SUBMISSIONS REPORT

TOGA Central

SSD-33258337

Prepared for
TOGA CENTRAL DEVELOPMENT PTY LTD
20 December 2022

Figure 5 Comparison of proposed design configuration of internal fPPb void

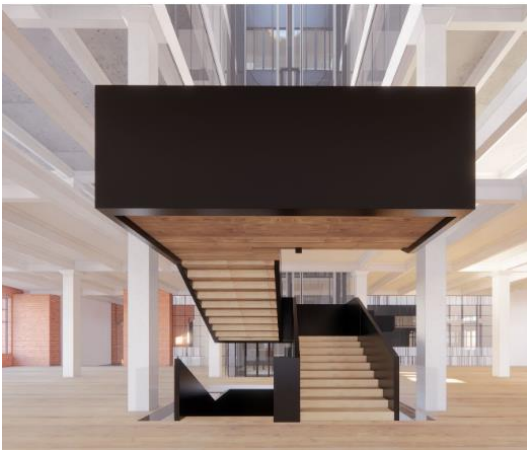
The extent of proposed internal demolition has been revised in response to the City of Sydney submission. As outlined in **Section 3.2**, the central atrium (and level 7 roof) has been rationalised resulting in a reduction in the size of this internal void and extent of internal demolition. The width of the void between Grids I - K along the main building core has also been reduced. The amendments to the void will ensure that natural daylight is penetrated throughout the building.

The roof of the central atrium at the level 7 terrace has also been adjusted to match this design, providing a simplified overall expression in better alignment with the original heritage building. This also supports additional daylight penetration to the lower levels.

A comparison of the previously submitted void configuration and the proposed void configuration is provided in **Figure 5**.

Figure 6 Proposed refinement of southern atrium stairway

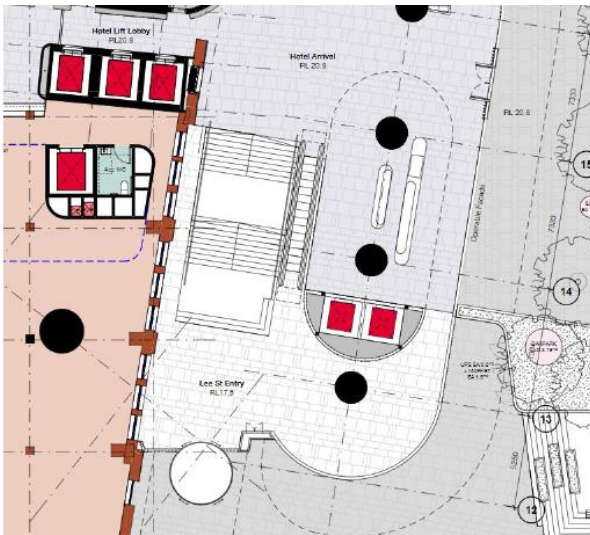
In response to commentary received from Council and the DPE, the southern atrium stairway has been offset by 900mm from the southern façade of the fPPb to provide greater curtilage to the heritage fabric, and specifically the two former bronze framed shopfronts located on the northern end of the façade. The refinement allows the stair to be entirely separate from the southern façade, as illustrated in **Figure 6**.

The design has been revised to provide a greater offset of the proposed atrium stair from the southern façade of the fPPb. A 900mm offset is provided to allow for greater visibility and curtilage to the bronze framed shopfronts.

Figure 7 Location of land at RL21

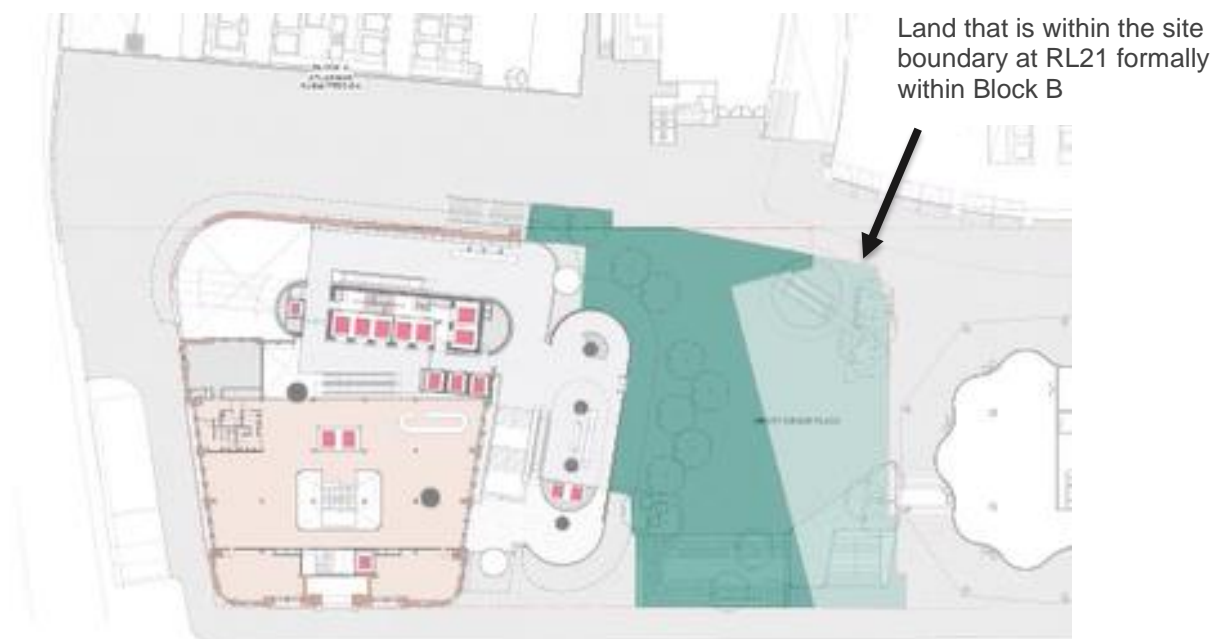
In regard to the lot boundary, it is noted the site has a number of complex stratum site ownership arrangements that are to be resolved in a future subdivision and lot re-alignment process. The lot boundary and site ownerships within the site are discussed in **Section 3.2.2**. In response to the location of works within the adjacent site, the following is noted:

The owner of the land within the development boundary 'above RL 21' is TfNSW. The primary leaseholder is the Dexu-Frasers Consortium. The TfNSW landowners' consent letter (to be provided prior to determination) will confirm consent for the construction of building works on both the Block C and Block B land. This will be supplemented by a confirmation letter from the Block B leaseholders, the Dexu-Frasers Consortium, confirming consent is provided to construct on their leasehold land above RL21.

Figure 11 Comparison of original historic openings and proposed openings in rear yard wall

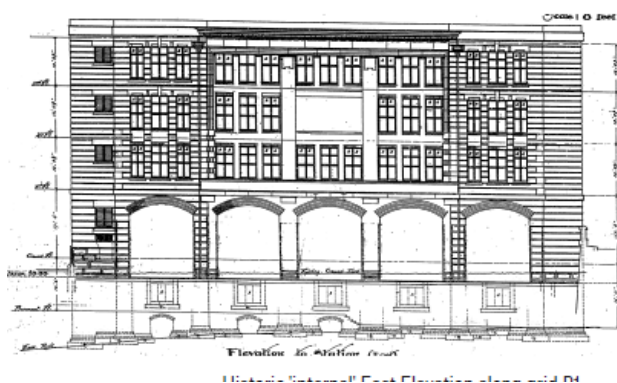
The new openings within the rear yard retaining wall are retained within this Submission Report. The development proposes three entryways and full-length windows within the openings to connect the Atlassian lower ground link zone and the TOGA lower commercial lobby. These openings are consistent with the original historical function of this space in passing parcels onto the platform, and the size of the large format openings is consistent with the proportions of the original openings (refer **Figure 11**).

Whilst the proposal does seek additional openings than the original (which had at least two), the additional openings are supported by Urbis Heritage due to the creation of a viable pedestrian link and a significant contribution to the quality of this public domain area (particularly noting the high level of pedestrian movement in the 2056 + 15% future scenario).

Regarding the proportions, the proposed openings adopt a squared top rather than the original arches. This is proposed to ensure the openings are read as a new intervention (particularly to the south where no openings were originally located), and that the openings are sympathetic to the new vaulted ceilings within the lower ground link zone.

Figure 12 Setback diagram

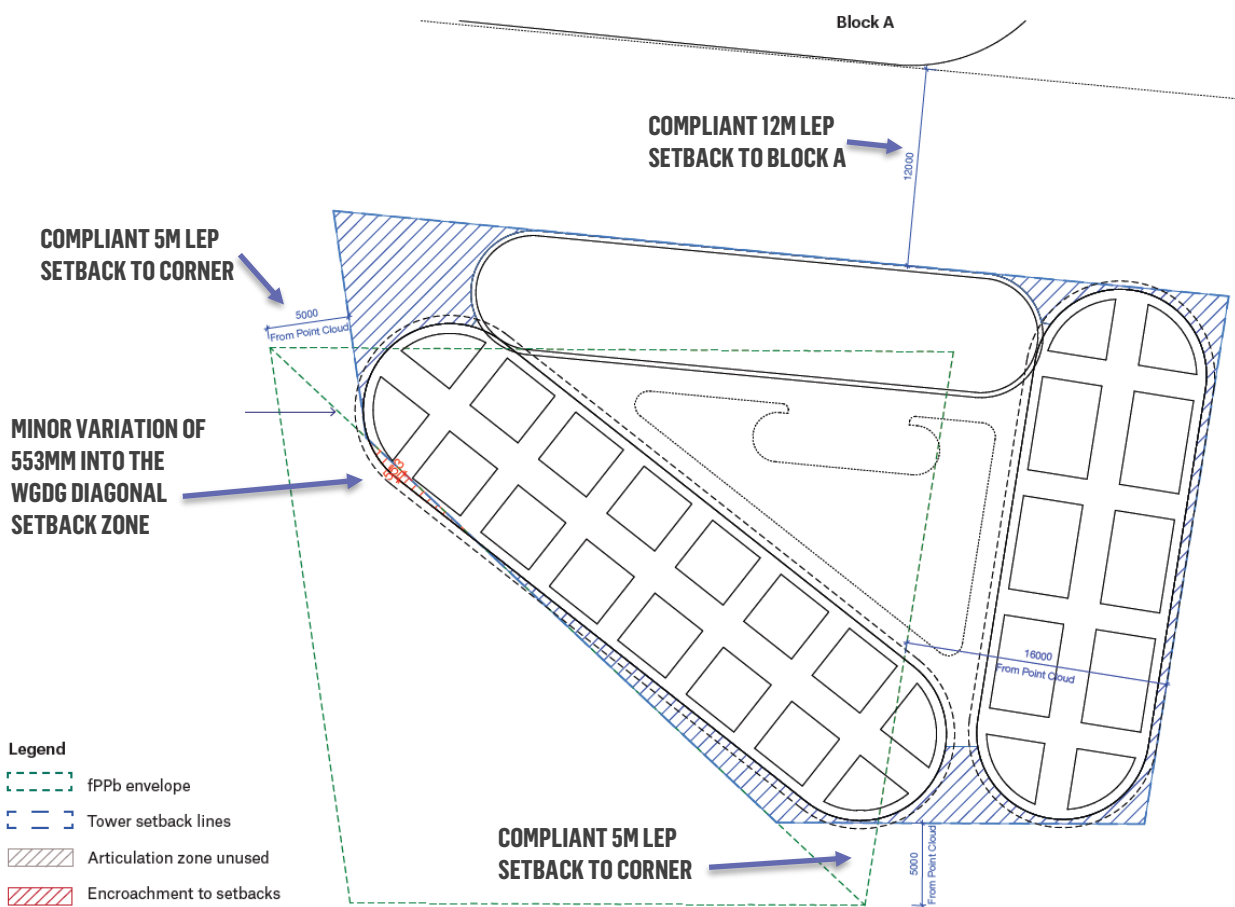
An updated setback diagram is provided in the RTS Design Report at **Appendix E** and extracted at **Figure 12**.

- The expression of the tower form in three distinct pill forms results in an area of unused articulation located south of the diagonal line, as identified in the blue crosshatch in **Figure 12**. Specifically, the northern pill is setback 2.06m from the diagonal line. The total area of the unused articulation in the envelope is 154sqm. As such when considered overall, the substantive proportion of the tower envelope will be located south of the diagonal line in accordance with the intent of the control.
- The well-considered positioning of the tower form will ensure the fPPb retains its visual prominence when viewed from George Street and Pitt Street, and that a clear visual delineation between new and existing fabric is provided. Refer to further discussion in the revised Heritage Impact Statement (**Appendix G**).

Figure 14 Comparison of interim and final Henry Deane Plaza

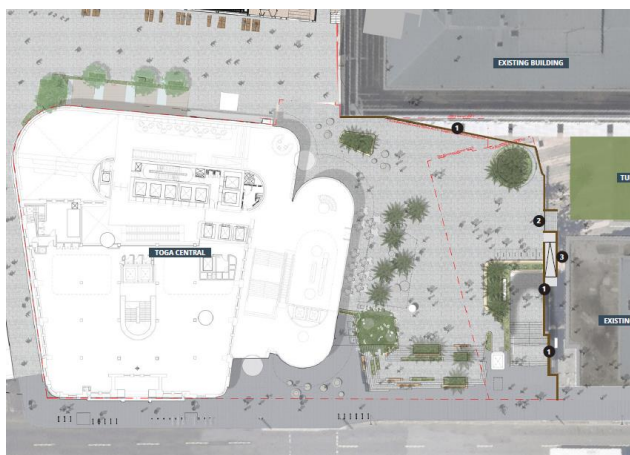
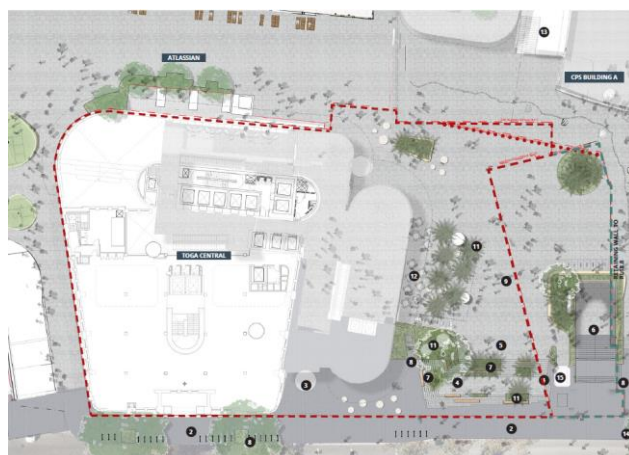
A comparison of the interim and final public domain interface with adjoining blocks is provided in **Figure 14**.

The Landscape Plans illustrate the design of the public domain in the interim scenario (in the event Central Place Sydney is not developed). In this scenario, the following elements are provided:

- An interim brick wall with a vertical face and safety balustrade on the south-eastern site boundary (to resolve level differences),
- Interim stairs and an interim ramp from RL 16 up to the new Henry Deane Plaza level at RL21.
